June 3, 2021

The MIL Is Flashing with Loss of Power

Year	Model	Trim Level	VIN Range
2018–21	Accord	ALL 2.0L Turbo with 10 A/T	ALL

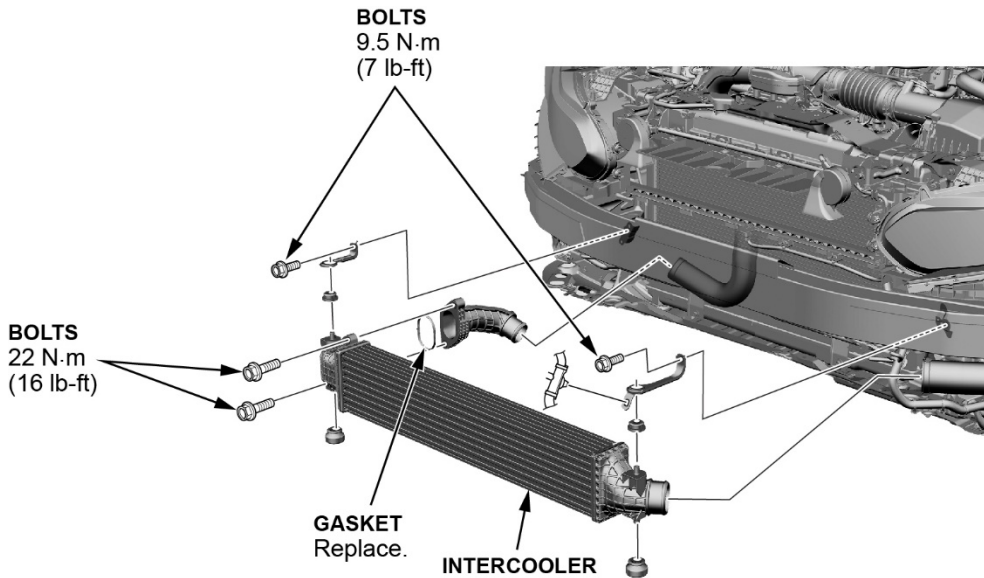
2. Remove the intercooler.

3. Install the new intercooler and gasket, and torque the two bolts mounting the intercooler to **22 N·m (16 lb-ft)** and the two bolts with brackets to **9.5 N·m (7 lb-ft)**.

GOOD

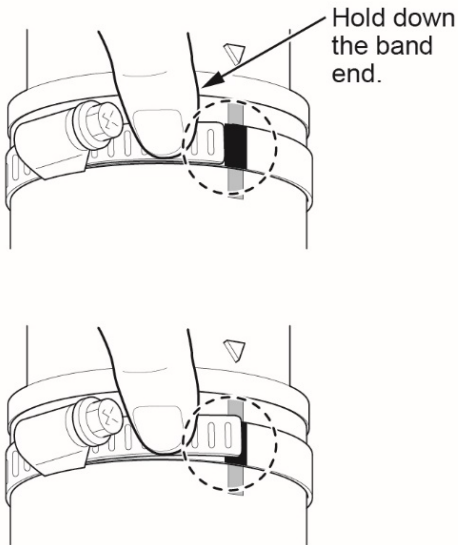
4. Tighten the hose bands to the specified condition below.

The hose band end is **AT** or **WITHIN** the paint or hash mark on the hose band.

NO GOOD

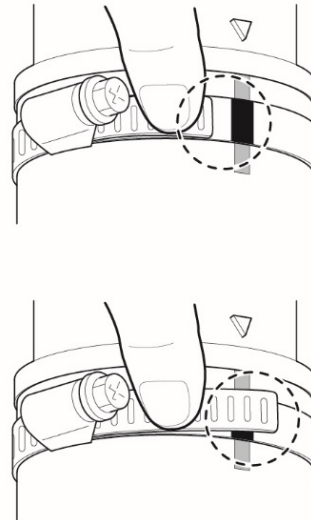
The hose band end is **NOT AT** or **EXCEEDS** the paint or hash mark on the hose band.
